Lot: 142

Model: 40.02 A VALLEYVIEW

Project/Phase: Pine Valley Forevergreen / 1

BASEMENT | ELEV. A

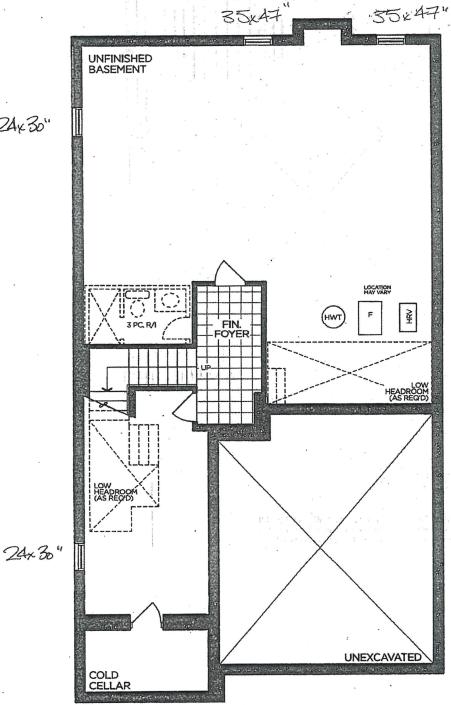
Invoice	Qty.	Description
2267 72,351	2	BASEMENT WINDOWS - UPGRADE BASEMENT WINDOW SIZE TO 30 " X 24" - 8" FRAME.
2305 72,672	2	BASEMENT WINDOWS - EGRESS BASEMENT WINDOW 47 " X 35" - 8" FRAME- REAR ONLY.
		REAR ONLY

24×30"

91 ŒiLING

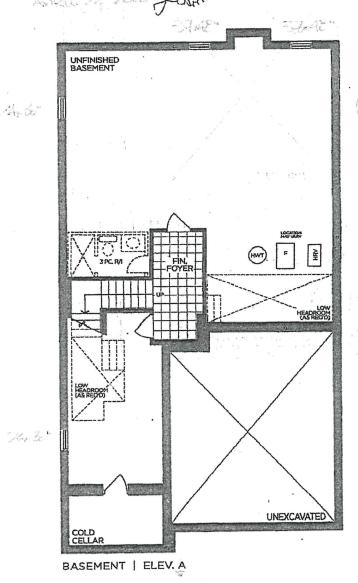
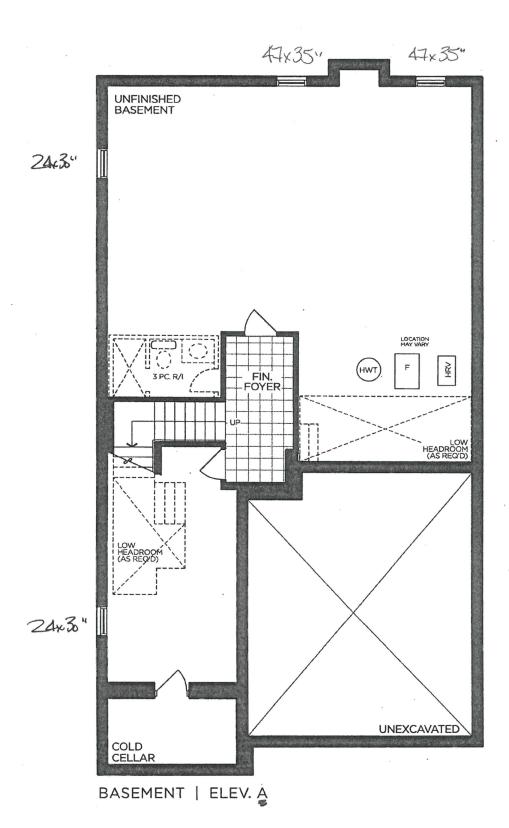
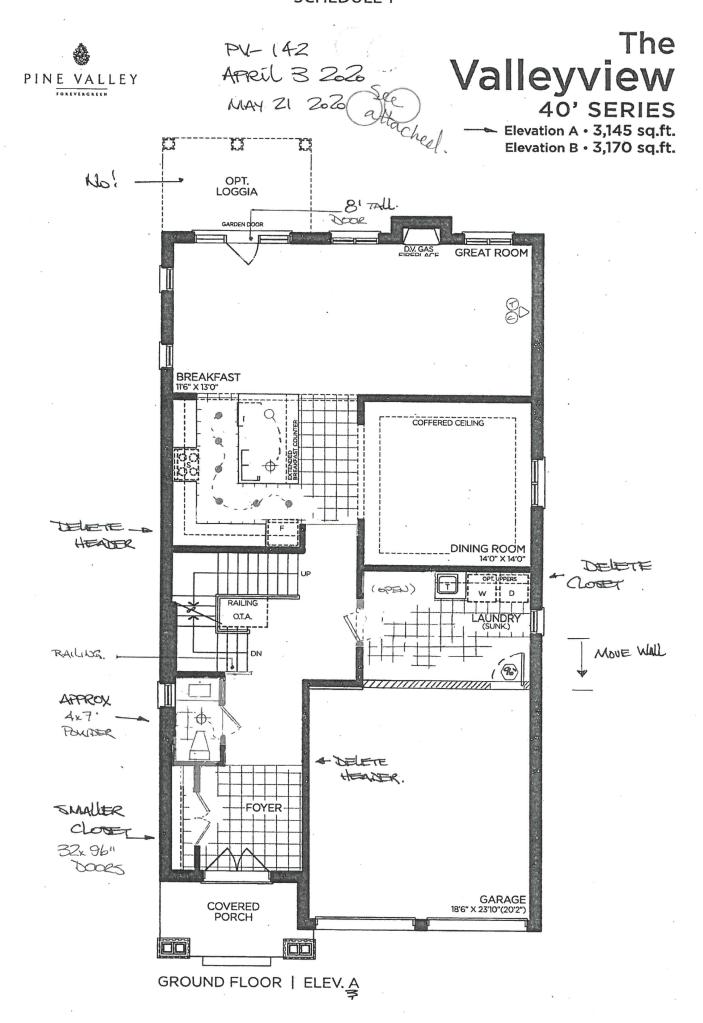
Invoice	Qty.	Description
2267	1	.***REVISED LAYOUT*** MOVE REAR GARAGE WALL APPROX 3' (SQUARE OFF REAR OF GARAGE) TO CREATE LARGER LAUNDRY ROOM. MOVE DOOR FROM GARAGE TO HOUSE CLOSER TO EXTERIOR WALL. SEE PLAN FOR LOCATION. [COMPLETE WITH STANDARD LEVEL FINISHES]
NoCat		
2347	1	.**CUSTOM LAYOUT** REVISE LAYOUT OF POWDER ROOM. INTERIOR OF POWDER ROOM TO BE APPROX. 4'X7'. REDUCE FOYER CLOSET TO ACCOMMODATE, INSTALL LARGER CLOSET DOORS - SEE ATTACHED SKETCH
NoCat		
2347	1	***CUSTOM LAYOUT** DELETE CLOSET AT LAUNDRY
NoCat		
2347	1	.MASTER ENSUITE: ADD APPROX. 30" WIDE, FULL HEIGHT NIBB WALL AT END OF VANITY SEPARATING VANITY/TOILET
NoCat		
2347	1	.MASTER ENSUITE: REPOSITION TUB TO BE CENTERED BELOW REAR WINDOW - SEE PLAN FOR LOCATION
NoCat		
2347	1	.MASTER ENSUITE: SHOWER NICHE [SHAMPOO SHELF] - COMPLETE WITH MATCHING MARBLE JAMBS ON 4 SIDES, STANDARD TILE, APPROX. 12 X 18 INSTALLED VERTICALLY
NoCat

PAINT		
Invoice	Qty.	Description
2347	1	.**CUSTOM LAYOUT** REVISE LAYOUT OF POWDER ROOM. INTERIOR OF POWDER ROOM TO BE APPROX. 4'X7'. REDUCE FOYER CLOSET TO ACCOMMODATE, INSTALL LARGER CLOSET DOORS - SEE ATTACHED SKETCH
NoCat		
2347	1	.INCREASED HEIGHT TO MAN DOOR FROM HOUSE TO GARAGE (32X94") TALL HEIGHT - IF GRADE PERMITS (EACH)
NoCat		
2347	1	***CUSTOM LAYOUT** DELETE CLOSET AT LAUNDRY
NoCat		
2347	1	.**CUSTOM LAYOUT** ENSUITE 3/4: REMOVE WALL AND DOOR SEPARATING VANITY/WATER CLOSET - LEAVE 1 OPEN SPACE
NoCat		
2347	1	.**CUSTOM LAYOUT** REMOVE HEADER AND NIB WALL AT FOYER/MAIN HALL & MAIN HALL/KITCHEN
NoCat		
2347		.**CUSTOM LAYOUT** REMOVE DOUBLE DOORS AT MASTER BEDROOM, INSTALL SINGLE LARGER DOOR - MOVE TOWARD FRONT OF HOUSE. REMOVE DOOR TO WIC, CREATE APPROX 42" OPENING - NO HEADER OR NIBB WALLS AT WIC - SEE PLAN FOR LOCATION
NoCat		
2347	1	.**NOTE** INSTALL 32" X 96" DOOR FROM LAUNDRY TO HALLWAY

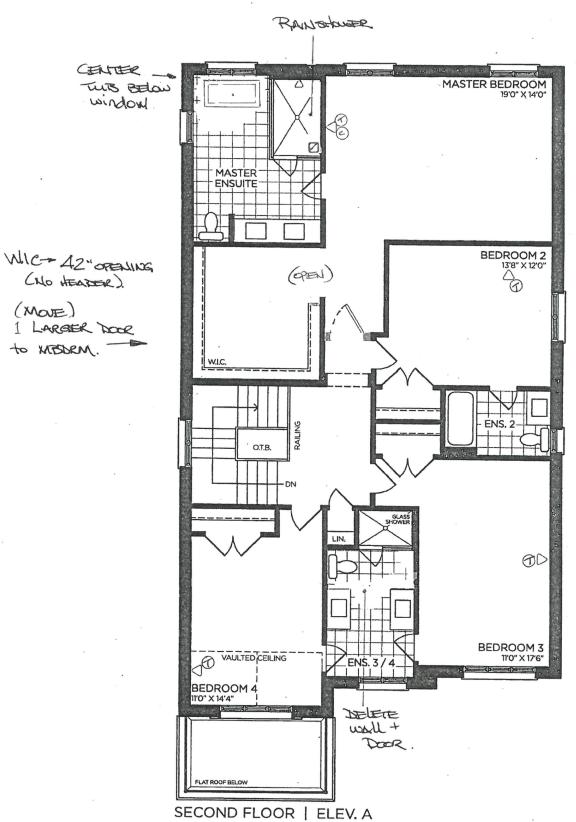
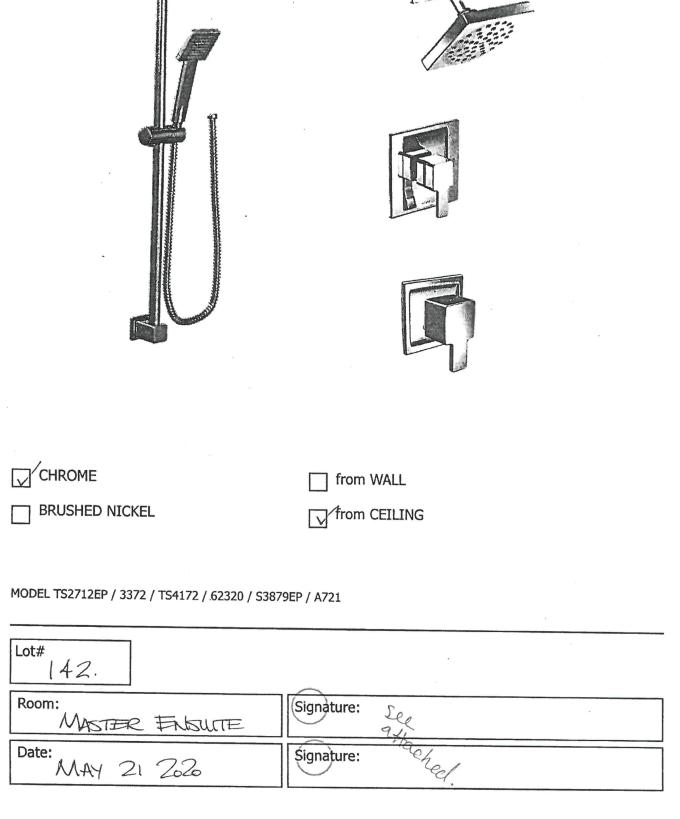
I LUMBING FIXTURES		
Invoice	Qty.	Description
2347	1	.MASTER ENSUITE: UPGRADE TO MOEN 90* RAIN SHOWER (from ceiling) + HAND SHOWER WITH SLIDE BAR 'CHROME' #TS2712EP/3372/TS4172/62320/S3879EP/A721
NoCat		
2347	1	.MASTER ENSUITE: REPOSITION TUB TO BE CENTERED BELOW REAR WINDOW - SEE PLAN FOR LOCATION
NoCat

POSI-TEMP SHOWER ONLY* W/ 3 FUNCTION TRANSFER VALVE/TRIM AND SLIDE BAR WITH HAND SHOWER

MOEN - 90 DEGREE

SCHEDULE T'

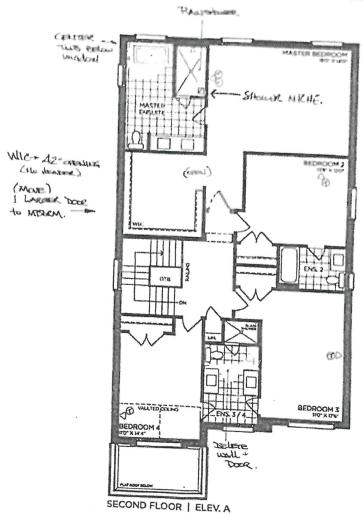
POSI-TEMP SHOWER ONLY* W/ 3 FUNCTION TRANSFER VALVE/TRIM AND SLIDE BAR WITH HAND SHOWER

MOEN - 90 DEGREE

BRUSHED NICKEL Trom CEILING MODEL TS2712EP / 3372 / TS4172 / 62320 / S3879EP / A721 Lot# 42. Room: Signature:		
Lot# 142. Room: MASTER ENSUTE Signature:	THE RELICUED NICKEL	
Room: MASTER ENSUITE Signature:	MODEL TS2712EP / 3372 / TS4172 / 62320 / S3879EP / A721	
MASTER ENSUITE		
Octor	Room: MASTER ENSUITE Signature:	
MAY 21 ZoZo Signature:	Date: MAY 21 ZoZo Signature:
